Final - APPLICATION AND  
PRELIMINARY PLAT CHECKLIST

**MURPHY PLAZA**  
EDWARD TEAL SURVEY, ABSTRACT NO. 207  
CITY OF ROCKWALL, ROCKWALL COUNTY, TEXAS

**Agenda Item:** Discuss and Consider Approval of a Site Plan for a Strip Center at FM-740 and Horizon Road

**Agenda Item:** P&Z 90-2-FP - Discuss and Consider Recommending Approval of a Replat of Certain Lots Located on /FM-740 South of Horizon Road to be Known as Murphy Plaza

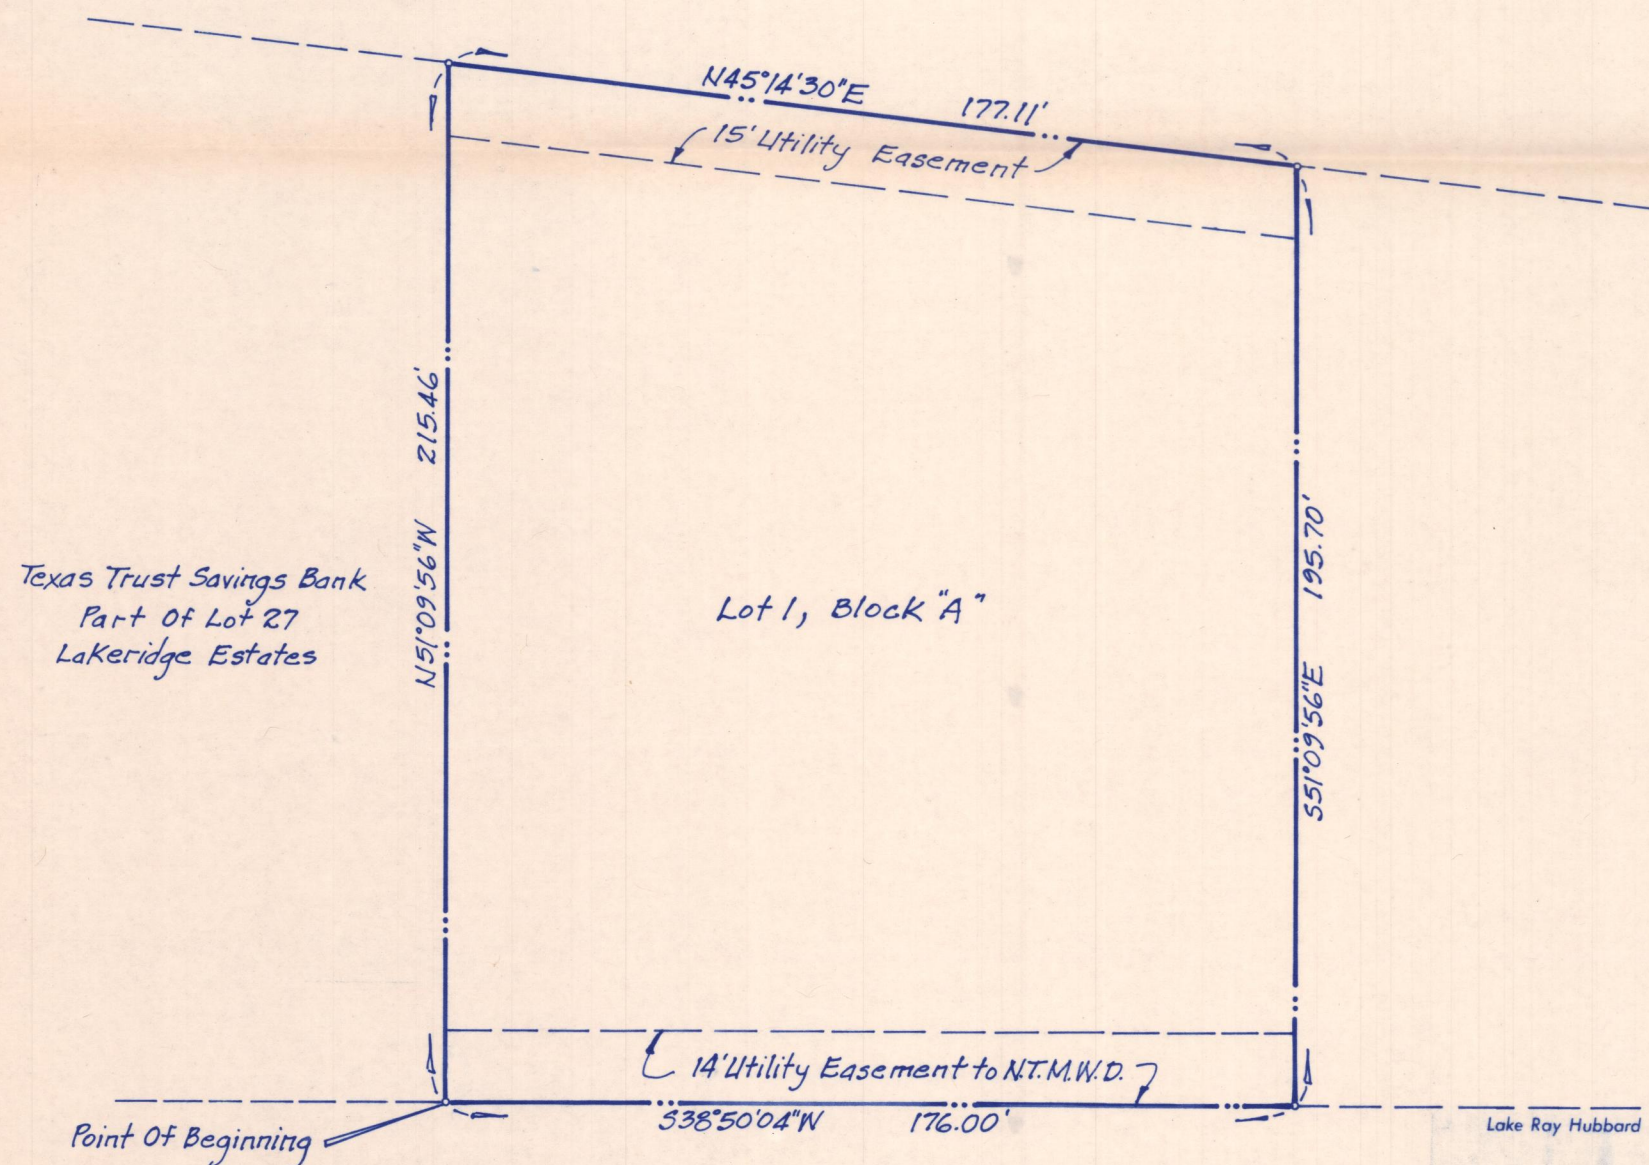
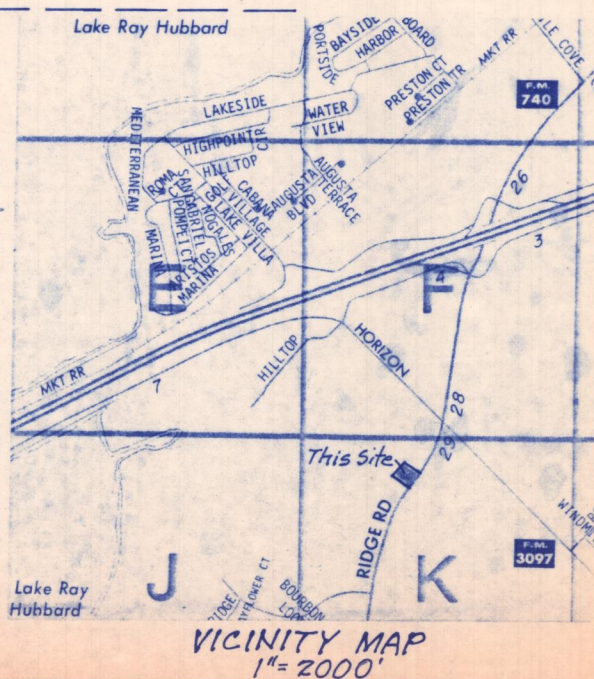
We have received a request for the replat of the two tracts owned by Danny Murphy. The plat meets all of our requirements with the exception that additional ROW must be provided along 740. Mr. Murphy's engineer is adding the dedication of 7.5 feet of ROW to the plat. This is in conformance with the standard design the state is using on FM-740 to the north. With the changes being made by the engineer we would recommend approval of the plat.

We have received a request for the replat of the two tracts owned by Danny Murphy. The plat meets all of our requirements with the exception that additional ROW must be provided along 740. Mr. Murphy's engineer is adding the dedication of 7.5 feet of ROW to the plat. This is in conformance with the standard design the state is using on FM-740 to the north. With the changes being made by the engineer we would recommend approval of the plat.

**SITE PLAN**

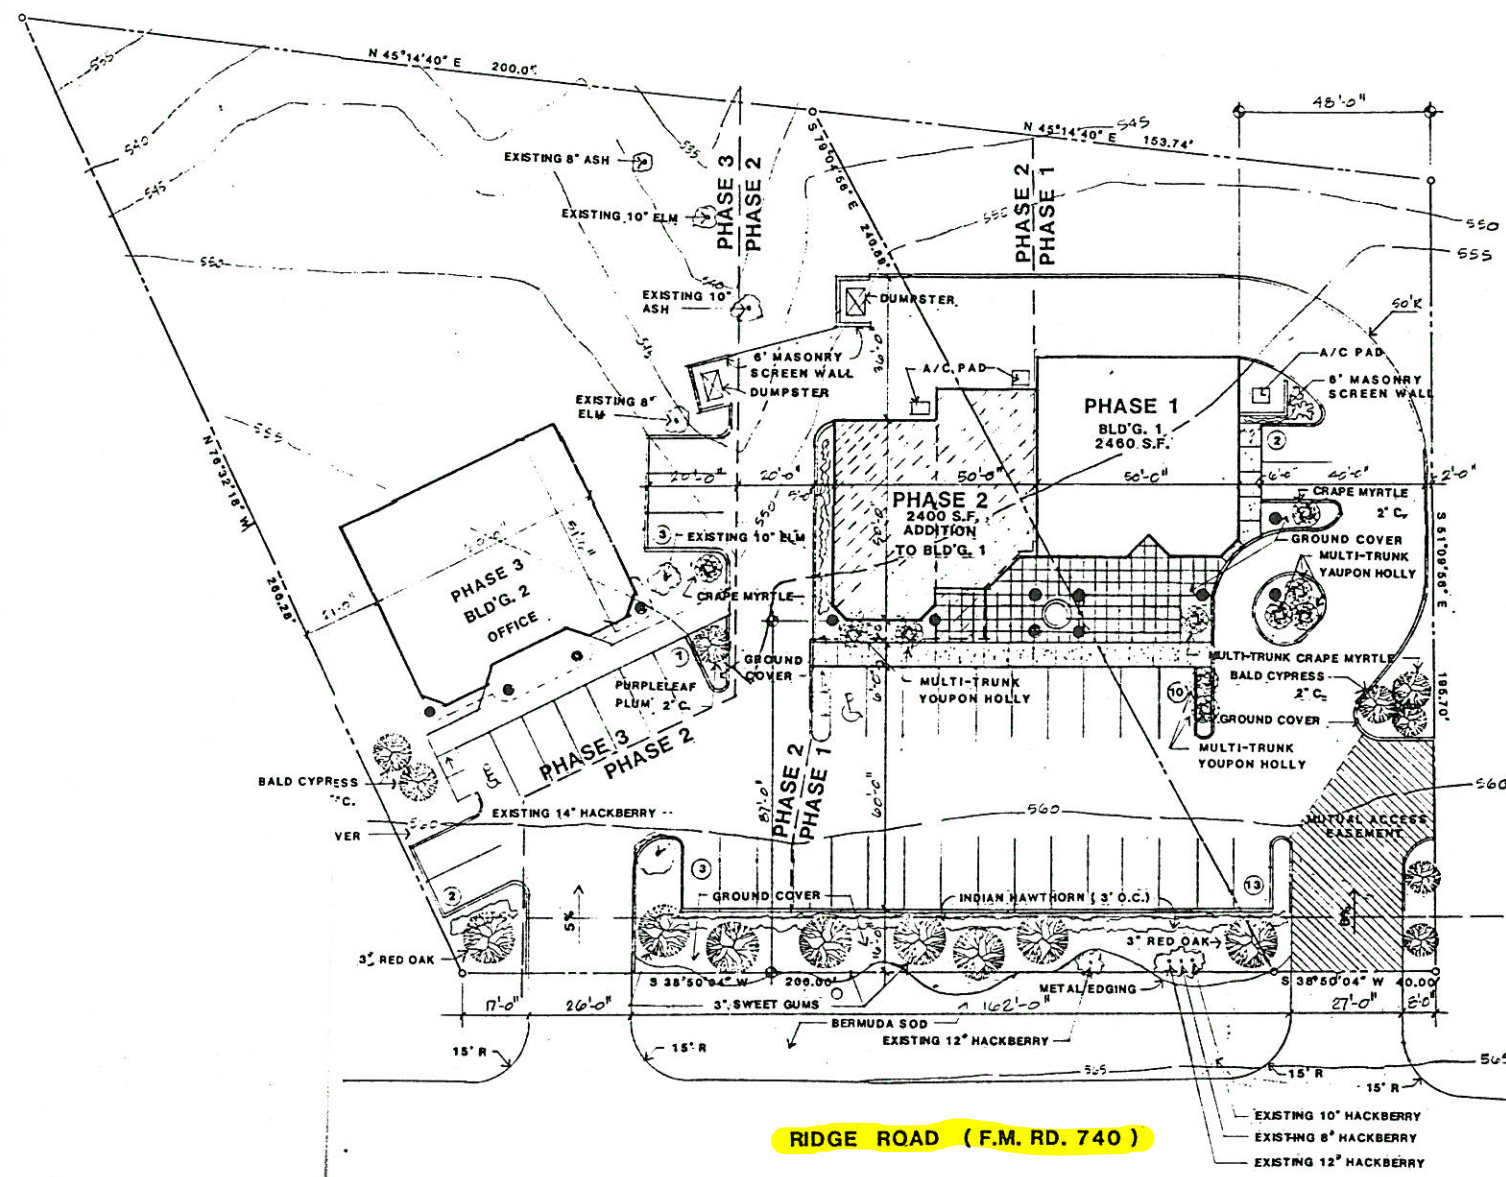
The plan has been reviewed by the Architectural Review Board because it is in the Overlay District and their recommendations are included below. The plan generally conforms to the Guidelines approved by the City Council for development within the District. The plan does propose to utilize tilt wall construction and some stucco as an exterior building material. The plan also generally utilizes a flat roof but contains a tower to offset the flat design. The Board generally recommended approval of the plan with the following conditions:

1. That more detailed elevations of all four sides identifying all outside building penetrations, and actual location of materials along with color samples be provided to the Commission.

2. That a parapet screening wall be provided on all four sides of the building. The applicant only intended a short parapet wall along the front and sides that would not have screened the equipment on the roof.

3. That the applicant provide more detailed information on the turning radii for the drive through and the site circulation be provided and that the Commission consider only one entrance into the site, not two as proposed. The zoning ordinance recommends that a minimum of 200 feet separate drives on arterials. The Board did not feel that two entrances were justified. The applicant has made the northern drive a joint access drive in order to ensure access to a future median break on FM-740 when it is widened to a 4-lane divided design in the future.

The applicant met with the Architectural Board on last Thursday. Because of some of the recommendations of the Board his architect is in the process of redesigning the site plan. The original submission planned the entire site. Because of the concerns of the Board he is now only going to site plan Phase One. The redrawing of the plan should be completed by Wednesday and we will forward it to you under separate cover. In order to give you a concept of their original submission and how the site will be fully developed, we have attached is a copy of the plan that was reviewed by the Board. With their resubmission you actually only be considering Phase One for approval at this time. The applicant will need to submit for site plan and elevation approval on Phase Two and Three. A representative of the Board will be present at Thursday's meeting to answer any questions you may have.

In addition to the changes recommended by the Board the applicant will need to make alterations in the landscaping to accommodate the changes that will be made in the circular drive area. This site is already platted as a part of the Lakeridge Estates Subdivision. This site will, however, have to be replatted to eliminate the lot line that currently divides the site. When the plat is considered additional ROW for FM-740 would be dedicated. The applicant is setting back from the existing ROW to accommodate future ROW as well as landscaping requirements.

It was pointed out that the current guidelines discourage tilt wall, stucco and flat roof designs and that this project incorporated all of these elements into its design. There was concern expressed regarding circulation from the northern entrance to the drive-through and the ability of cars to maneuver through the proposed turnaround. There was also concern expressed regarding the potential for traffic backups to occur at the northern entrance. Several members also voiced concern about having two entrances into the site less than 200 feet apart.

Gary McKibben made a motion that prior to submission to the Planning and Zoning Commission, elevations of the west and south sides of the building be developed for submission to the Commission detailing location, types and colors of all exterior materials and identifying all exterior penetrations, expansion joints, screening walls and plantings that would be used. He also included the statement in his motion that the exterior building materials proposed would be acceptable subject to submission of the stated items. John Lewis seconded the motion. The same was voted on and carried unanimously.

Gary McKibben then made a motion that a parapet wall be included on all four walls to screen roof mounted equipment. Rick Burgy seconded the motion. The same was voted on and carried unanimously.

Gary McKibben then made a motion that the applicant provide more detailed information on all turning radii especially for the drive through and the site circulation for Phase 1, and that the Commission consider one entrance into the site rather than two entrances as proposed. John Lewis seconded the motion. Same was voted on and carried unanimously.
